RE: Groundwater RI/FS Workplan Revision 1.0 Addendum
Further Pit F Groundwater Investigation
Ascon Landfill Site
Huntington Beach, California

CONDITIONAL APPROVAL OF WORKPLAN REGARDING FURTHER PIT F GROUNDWATER INVESTIGATION FOR THE ASCON LANDFILL SITE

Groundwater Remedial Investigation Workplan Revision 1.0 Addendum
Ascon Landfill Site
Huntington Beach, California

Figure 3

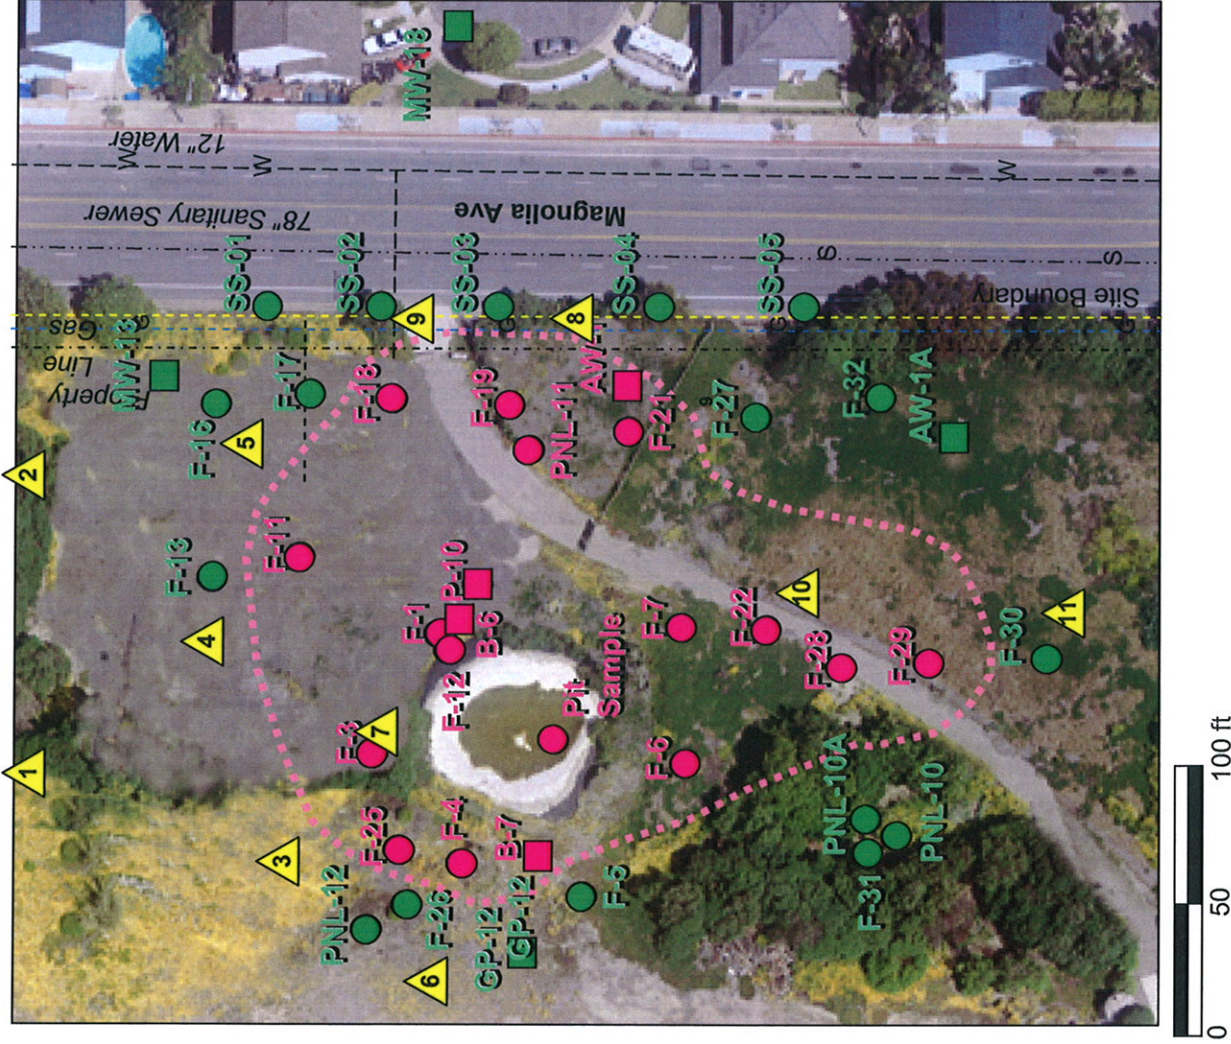
1. The field methodology should include measuring depth to water in nearby monitoring wells (i.e., MW-13, AW-1, AW-1A, and B-7) prior to the start of soil or groundwater sampling. This would provide the field team with a preliminary indication of the depth to groundwater for sampling purposes.

2. The groundwater sample for volatile organic compounds should be collected first. This allows for collection of the most volatile constituents before multiple deployments of the sampling tool and collection of higher volume samples.

3. The initial borehole used for soil sampling should be backfilled prior to beginning the borehole for collecting the groundwater sample. This would prevent ambient air in the initial borehole from entering the groundwater surface during groundwater sampling.

1. Groundwater levels at nearby wells (MW-13, AW-1, AW-1A, and B-7) will be recorded prior to fieldwork. The results will provide evidence as to changes in the level since the last monitoring (December 2004). However, as specified in the workplan and discussed with Frank Gonzales, the groundwater samples will be collected at a depth immediately below the clay/sand interface regardless of any changes in groundwater levels.

2. We agree. The groundwater sample for VOC analysis will be collected in each hole before the SVOC samples are collected in accordance with procedures outlined in the Groundwater Remedial Investigation/Feasibility Study Workplan-Revision 1.0 dated October 24, 2003. This is important not only to maintain the integrity of the VOC sample, but to ensure that there is sufficient sample for VOC analyses (i.e., SVOC analysis requires much more sample).

3. We agree. The initial borehole that is drilled adjacent to the sampling hole for determining lithology and the saturated zone will be backfilled prior to drilling the borehole for collecting the groundwater sample.
